Marin Headlands and Fort Baker Transportation Infrastructure and Management Plan

Final Environmental Impact Statement

March 2009

FIGURE 2.3 ALTERNATIVE 3 (PREFERRED ALTERNATIVE) — ENHANCED MULTI-MODAL ACCESS (ROADS, PARKING, AND TRANSIT IMPROVEMENTS)

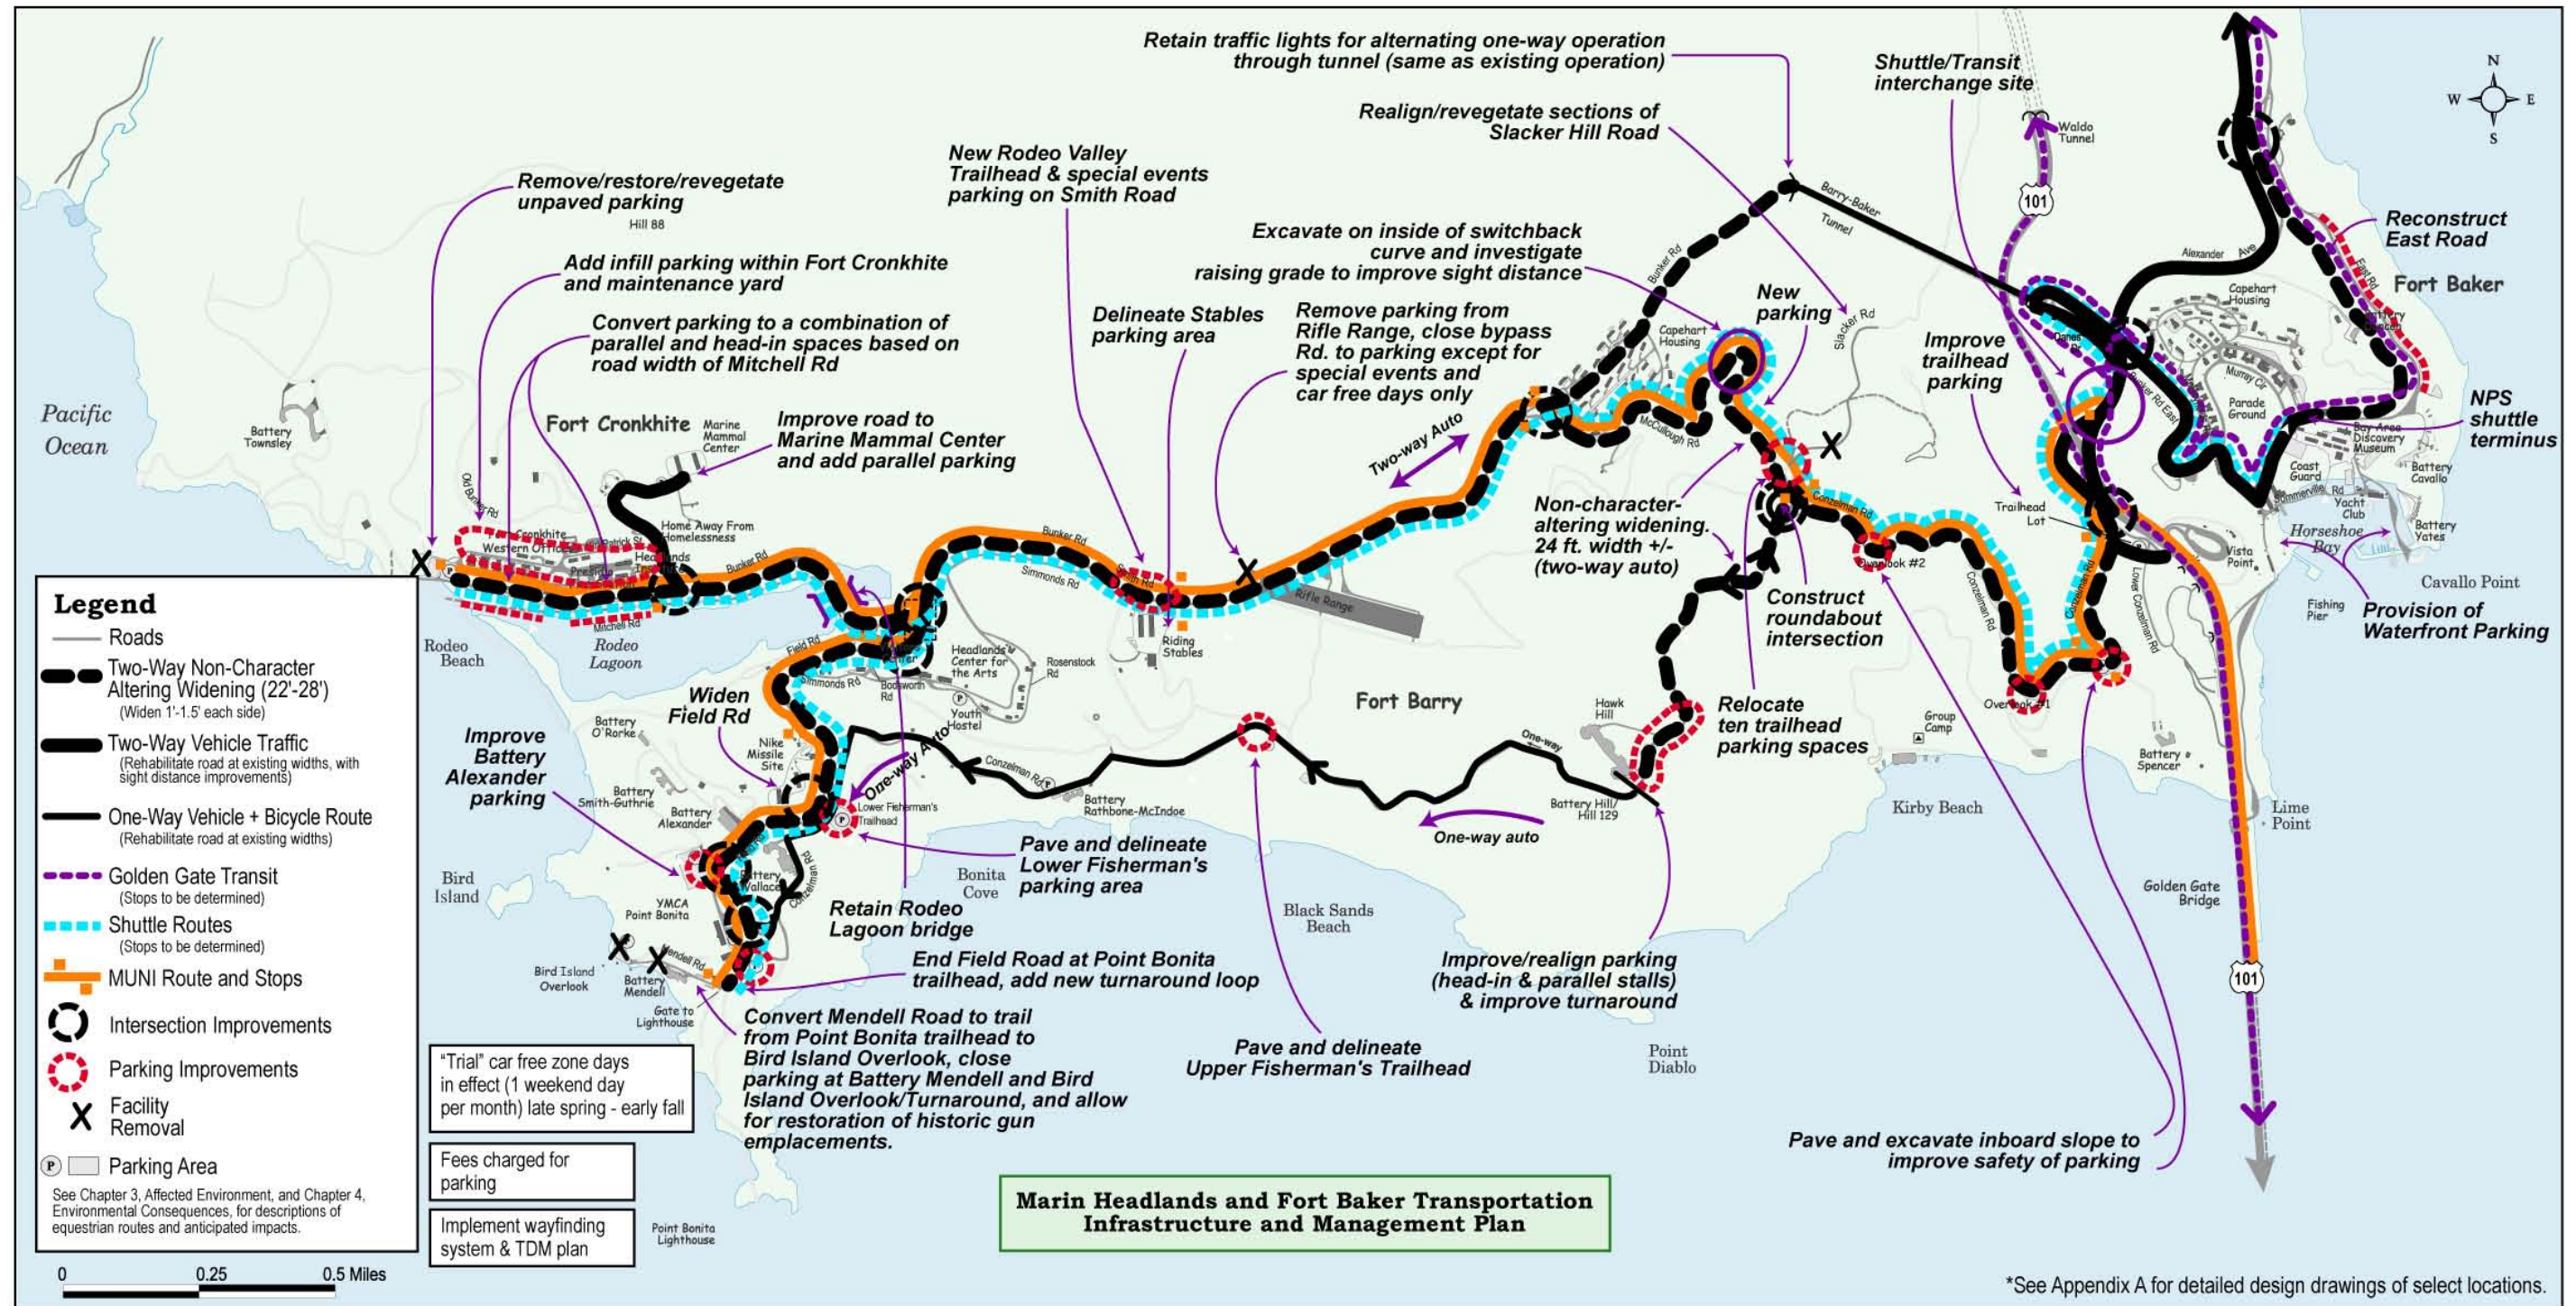
1. Section 2.5.5 describes Alternative 3 transit services and states that GGT Route 10 service on Alexander Avenue would continue with connections to other transit services at bus stops on the east and west sides of Highway 101 and with pedestrian/bicycle access at Danes Drive. However, Figure 2.3 and Table 2.1 show GGT operating on Bunker Road and East Road into Fort Baker. Further, it is not clear how connections between GGT and other services would be enabled at Highway 101 since GGT currently does not have a bus stop near Hwy. 101 in the southbound direction due to roadway conditions, and pedestrian access between the west and east sides of Highway 101 is constrained by the narrow underpass. Table 2.1 Summary of Alternatives, page 65, identifies bus stop and underpass improvements as future projects in Alternative 1 – the no-action alternative. District seeks clarification on how such apparently necessary improvements to GGNRA can be part of a no-action alternative.

In alternative 3, NPS would encourage the GGT Route 10 on Alexander Avenue to be rerouted to provide direct service to Fort Baker. Section 2.5.5 of the FEIS will be clarified for consistency with Figure 2.3 and Table 2.1, which show GGT operating on Bunker Road and East Road to provide service to Fort Baker.

- Response:** In Alternative 3, the GGT Route 10 on Alexander Avenue would be rerouted to provide direct service to the main post area of Fort Baker. Section 2.5.5 of the FEIS will be clarified for consistency with Figure 2.3 and Table 2.1, which

FIGURE 2.6 ALTERNATIVE 2 — BASIC MULTI-MODAL ACCESS (ROADS, PARKING, AND TRANSIT IMPROVEMENTS)

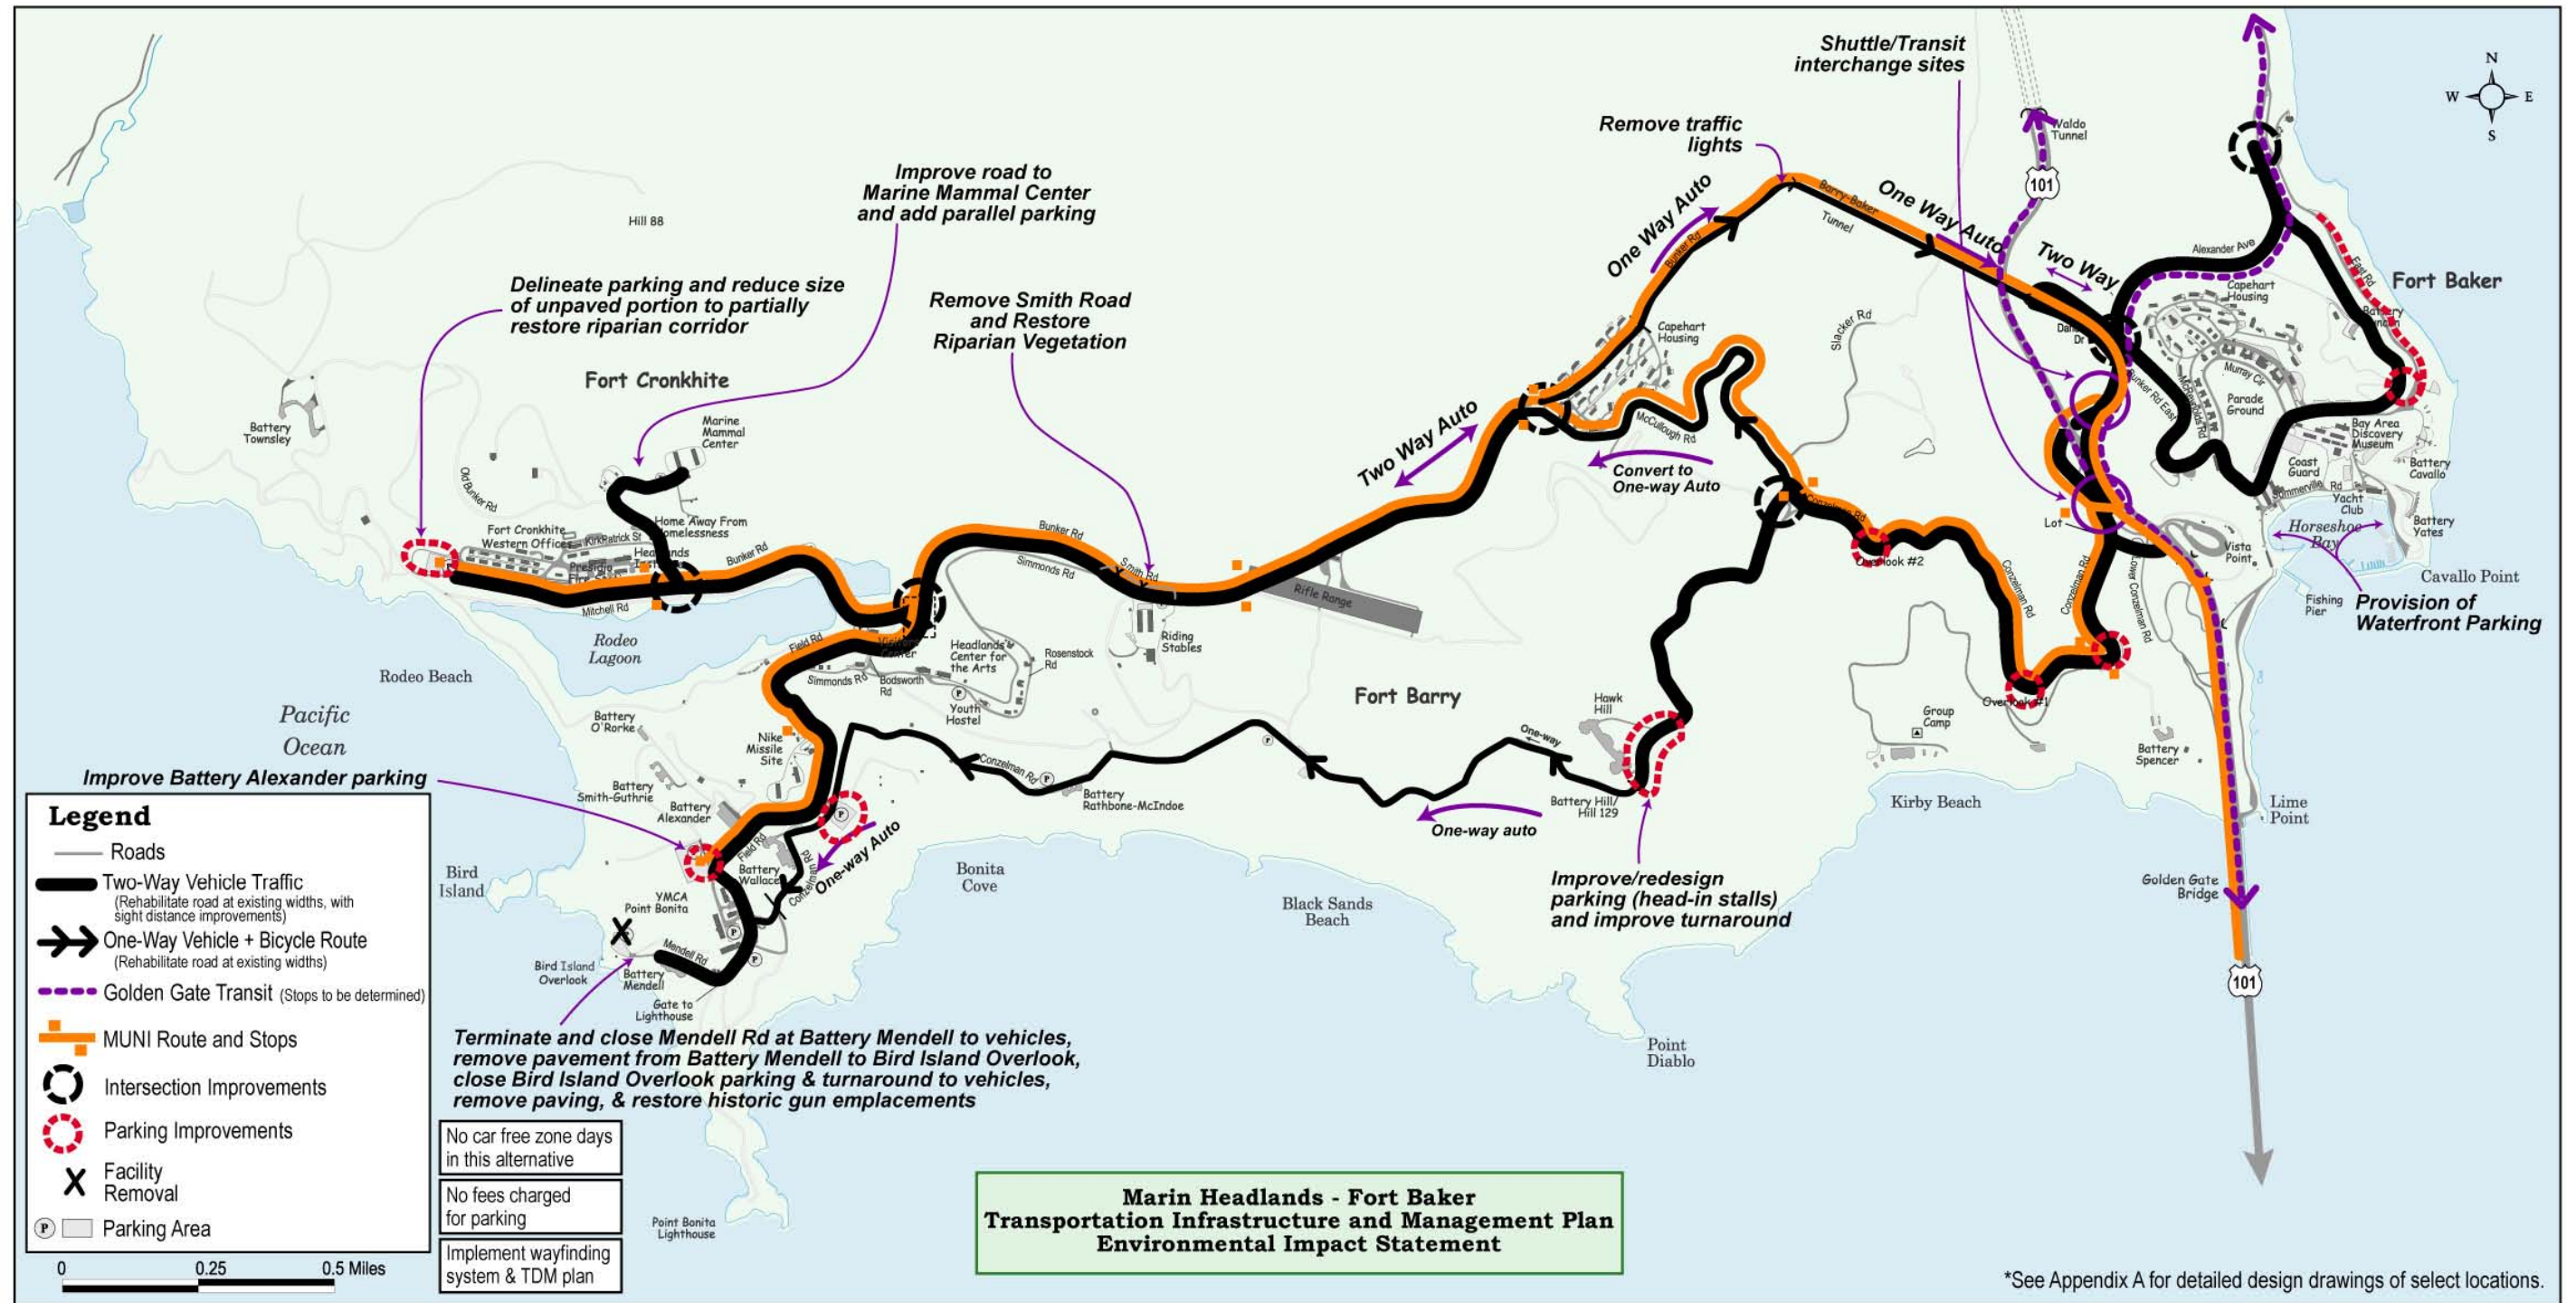
2. Section 2.6.5 describes Alternative 2 transit services. Figure 2.6 also shows the Highway 101 transit connection locations described in Section 2.5.5 and we reiterate our related comment above.

CONCERN STATEMENT: Section 2.6.5 describes Alternative 2 transit services. Figure 2.6 also shows the Highway 101 transit connection locations described in Section 2.5.5 and we reiterate our related comment above.

Response: In Alternative 3, the GGT Route 10 on Alexander Avenue would be rerouted to provide direct service to the main post area of Fort Baker. Section 2.5.5 of the FEIS will be clarified for consistency with Figure 2.3 and Table 2.1, which show GGT operating on Bunker Road and East Road to provide service to the main post area.

FIGURE 2.8 ALTERNATIVE 4 — MAXIMUM MULTI-MODAL ACCESS (ROADS, PARKING, AND TRANSIT IMPROVEMENTS)

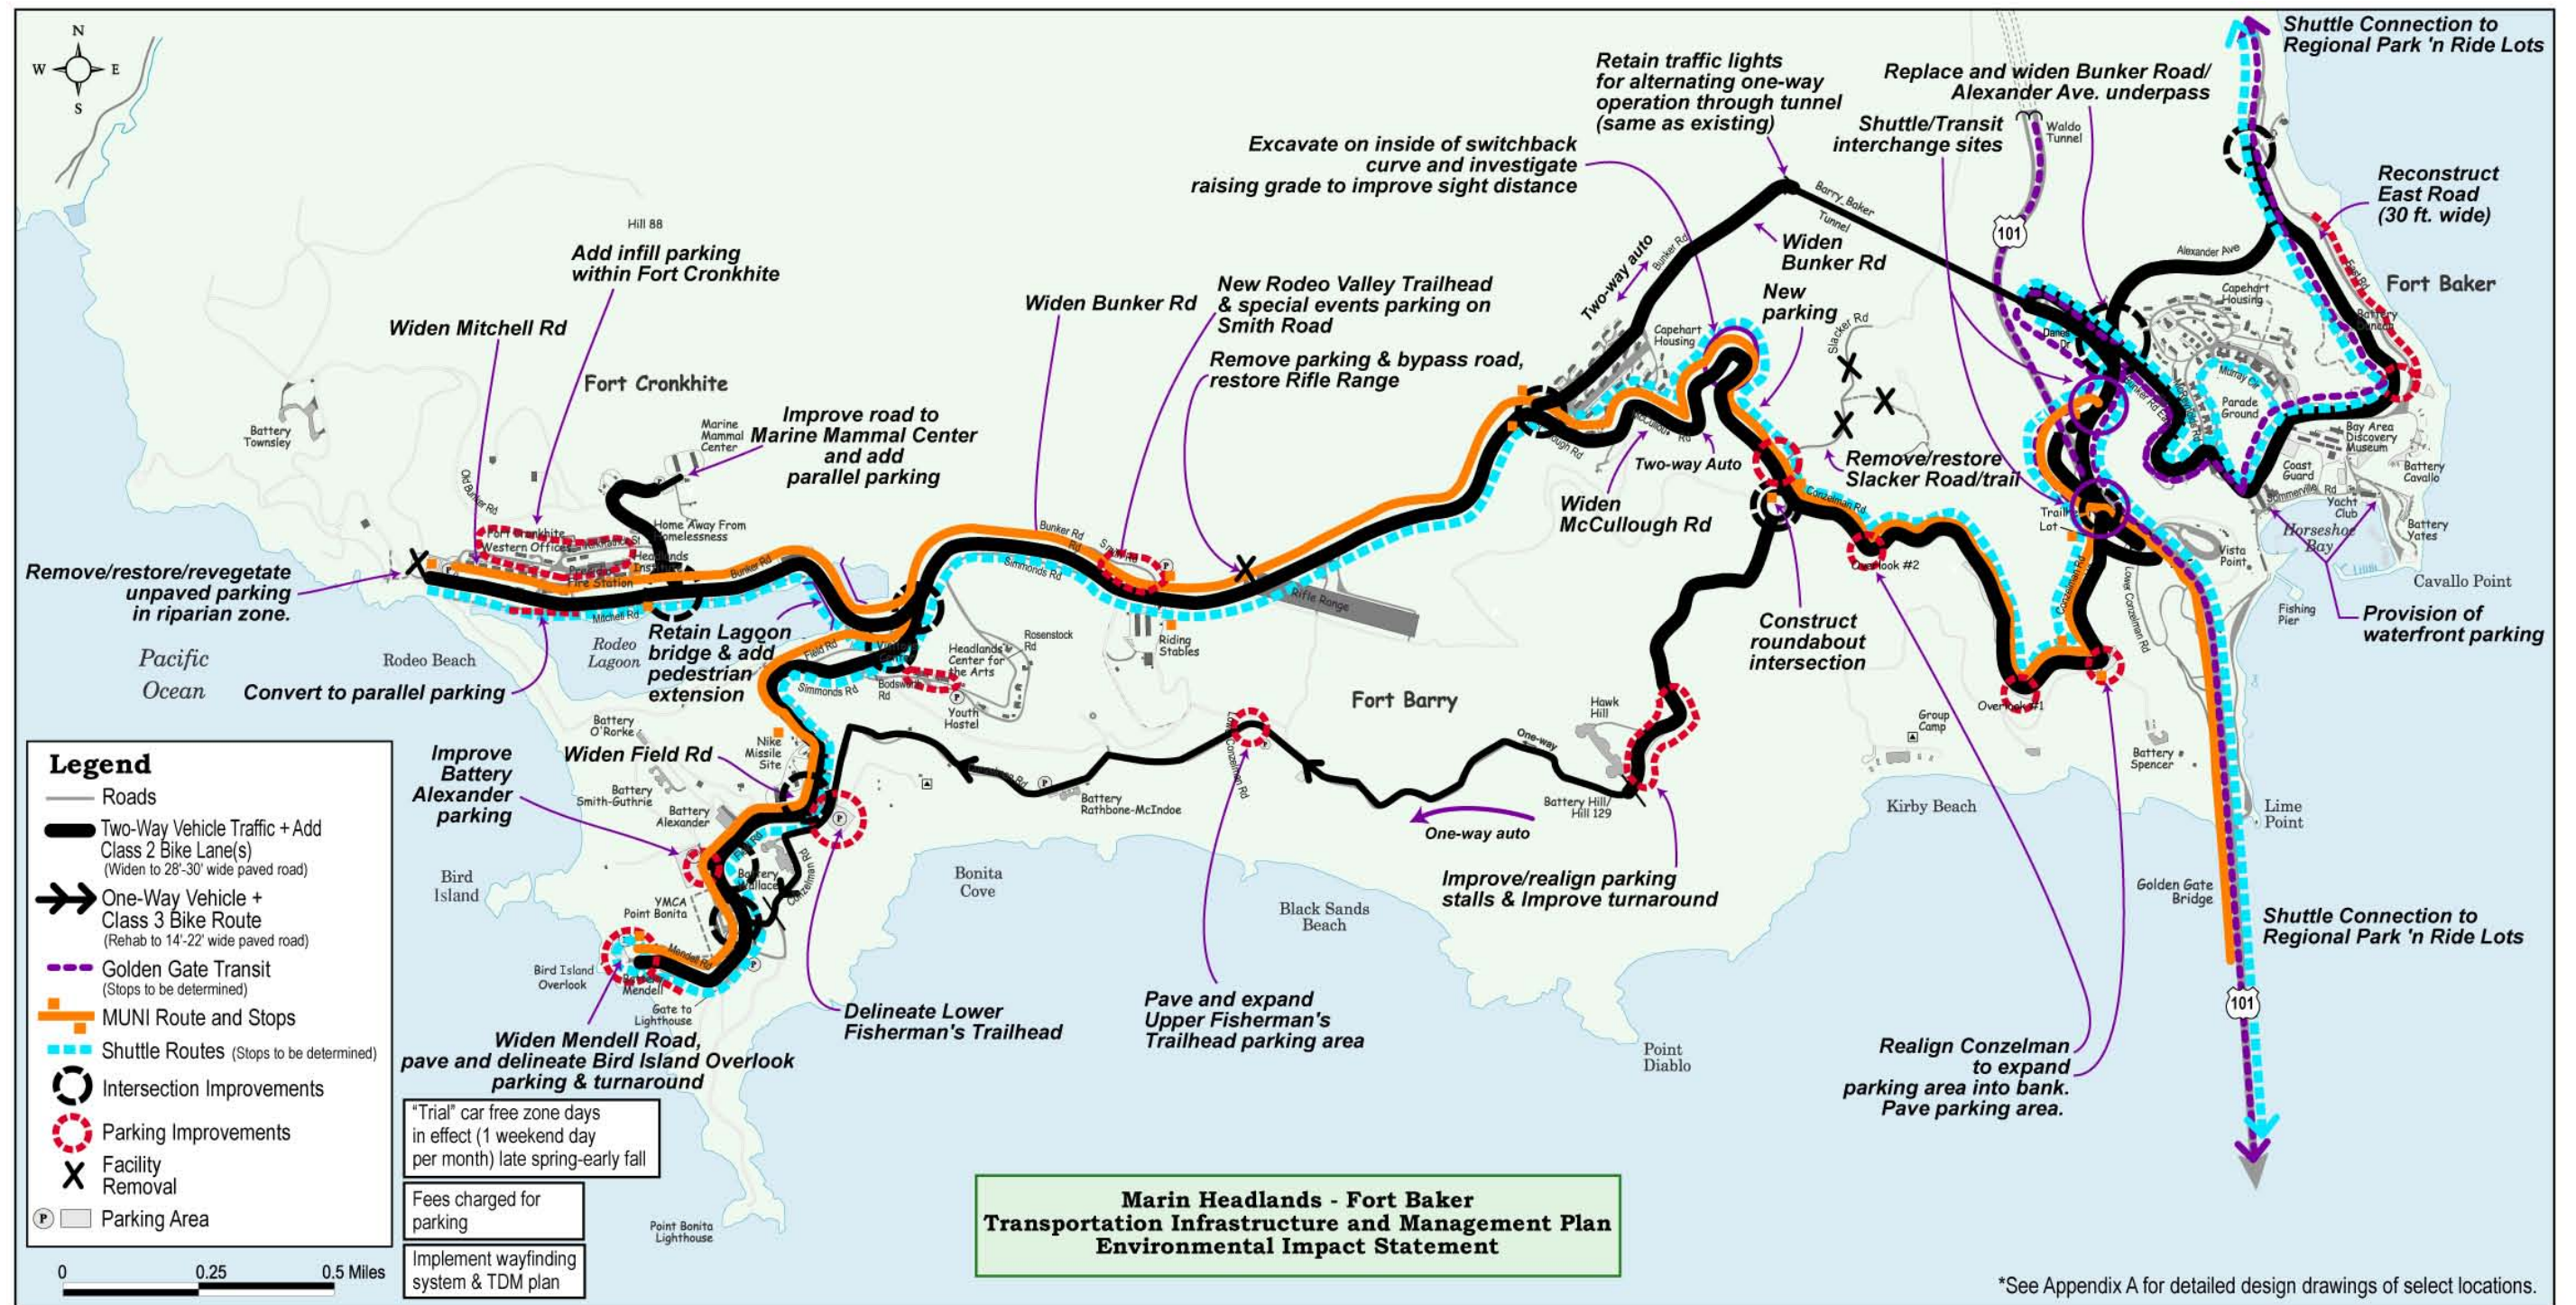
3. Section 2.7.5 describes Alternative 4 transit services. Figure 2.8 shows GGT operating on Bunker Road and East Road into Fort Baker. District staff had previously informed GGNRA staff and consultants of need for roadway improvements, such as wide lanes and standard bus stops, to accommodate GGT bus operations and bus stops at Fort Baker. Please clarify if such improvements are

| <p>included in GGNRA plans. Figure 2.8 also shows the Highway 101 transit connection locations described in Section 2.5.5 and we reiterate our related comment above.</p> | J-6 cont. |

Section 2.7.5 describes Alternative 4 transit services. Figure 2.8 shows GGT operating on Bunker Road and East Road into Fort Baker. District staff had previously informed GGNRA staff and consultants of need for roadway improvements, such as wide lanes and standard bus stops, to accommodate GGT bus operations and bus stops at Fort Baker. Please clarify if such improvements are included in GGNRA plans. Figure 2.8 also shows the Highway 101 transit connection locations described in Section 2.5.5 and we reiterate our related comment above.
